Cylinder Head Bolts: Technical Service Bulletins

95-3-10

ENGINE - 5.0L - NEW TORQUE-TO-YIELD CYLINDER HEAD BOLT KIT AND NEW PROCEDURES - SERVICE TIP

Figure 1

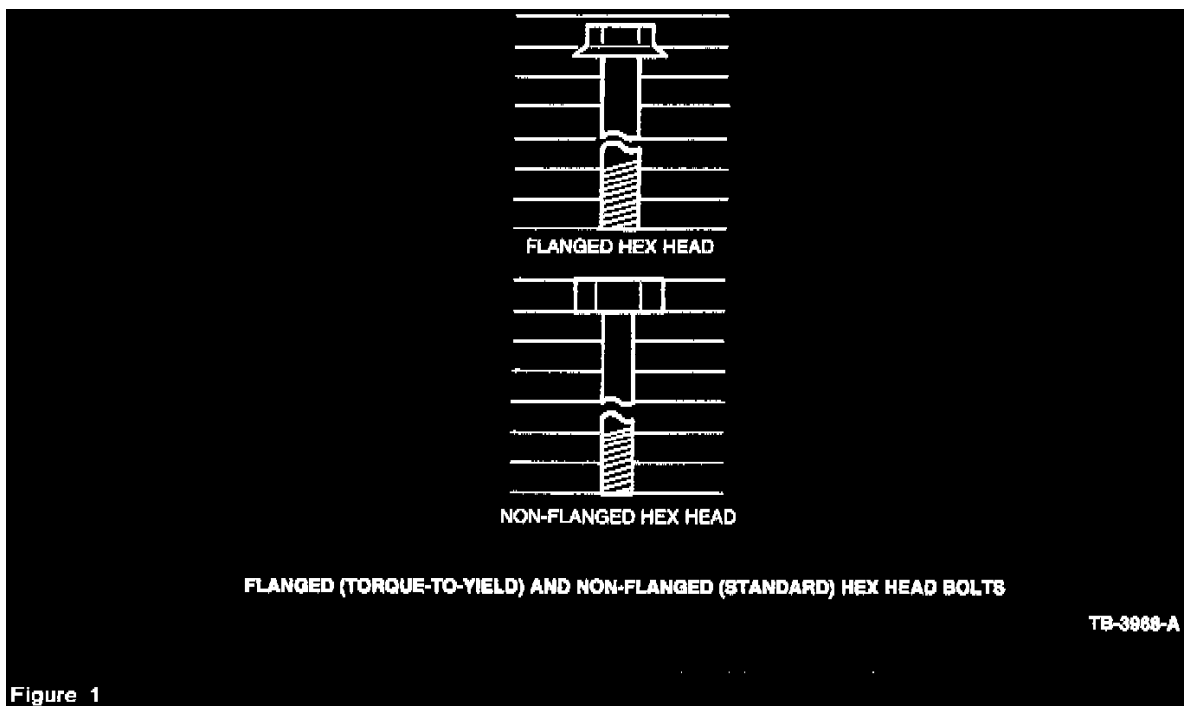
In 1992, the type of cylinder head bolts used on the 5.0L engines was changed to the torque-to-yield bolts. Depending on the build date of the engine, the 1992 model year engines came with either torque-to-yield bolts or standard torque, not a combination of the two (2). In 1993, torque-to-yield bolts were used on all 5.0L engines.

^ The two (2) types of bolts being used are physically different. Refer to Figure 1.

^ The standard torque bolt is a non-flanged hex head bolt.

^ The torque-to-yield bolt is a flanged head bolt.

^ The bolts must be all the same style on each cylinder head.

DO NOT USE BOTH TYPES OF CYLINDER HEAD BOLTS ON ONE (1) CYLINDER HEAD. EACH CYLINDER HEAD MUST HAVE

ALL OF ONE (1) TYPE OF RETAINING BOLT: STANDARD TORQUE OR TORQUE-TO-YIELD.

The torque-to-yield cylinder head bolts will be available only in a packaged kit (F3ZZ-6065-E). The kit will contain the following:

- ^ Five (5) 7/16-14x3.94 Bolts
- ^ Five (5) 7/16-14x2.49 Bolts
- ^ One (1) 3/8-16x7/16-3.93 Stud
- ^ One (1) Instruction Sheet (I.S. # 6605)

Figure 2

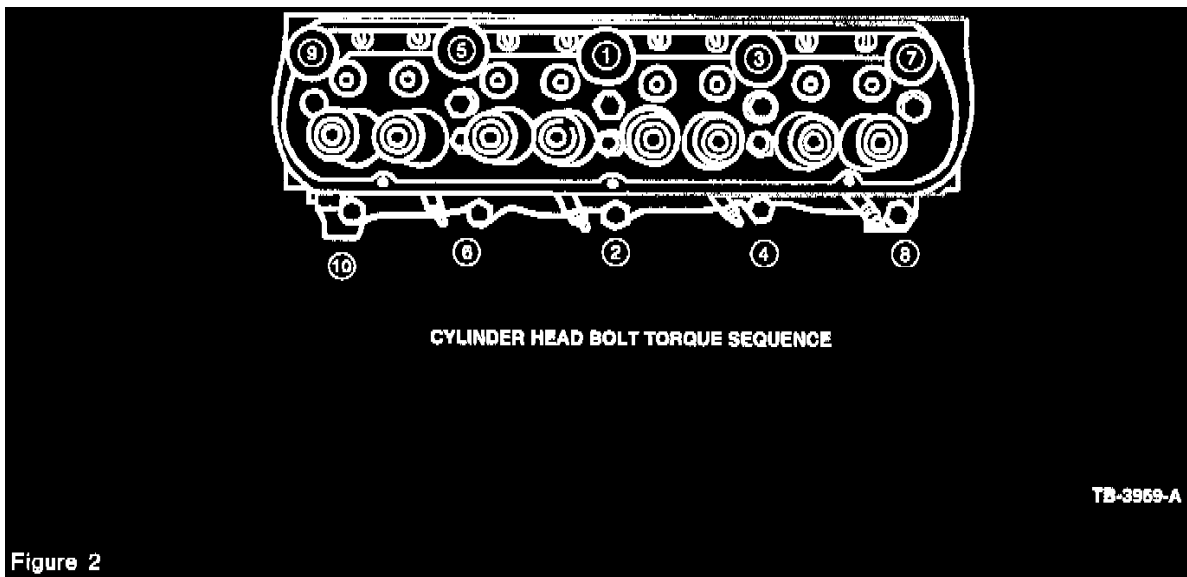
FOR THE NON-FLANGED STANDARD HEX HEAD BOLTS, TIGHTEN IN TWO (2) STEPS AS FOLLOWS:

FOR ALL TORQUE TO YIELD HEX HEAD BOLTS, TIGHTEN IN THREE (3) STEPS AS FOLLOWS:

1. Tighten all bolts in sequence (Figure 2) to 75-88 N-m (55-65 lb.ft.).
2. Tighten all bolts in sequence (Figure 2) to 88-98 N-m (65-72 lb.ft.).

1. Tighten all bolts in sequence (Figure 2) to 34-47 N-m (25-35 lb.ft.).
2. Tighten all bolts in sequence (Figure 2) to 61-75 N-m 45-55 lb.ft.).
3. Tighten all bolts in sequence (Figure 2) an additional 1/4 turn (85-95 degrees).

CAUTION:
TORQUE-TO-YIELD CYLINDER HEAD BOLTS MUST BE REPLACED WITH NEW BOLTS. DO NOT REUSE TORQUE-TO-YIELD BOLTS. TORQUE-TO-YIELD BOLTS MAY ONLY BE USED ONE (1) TIME.
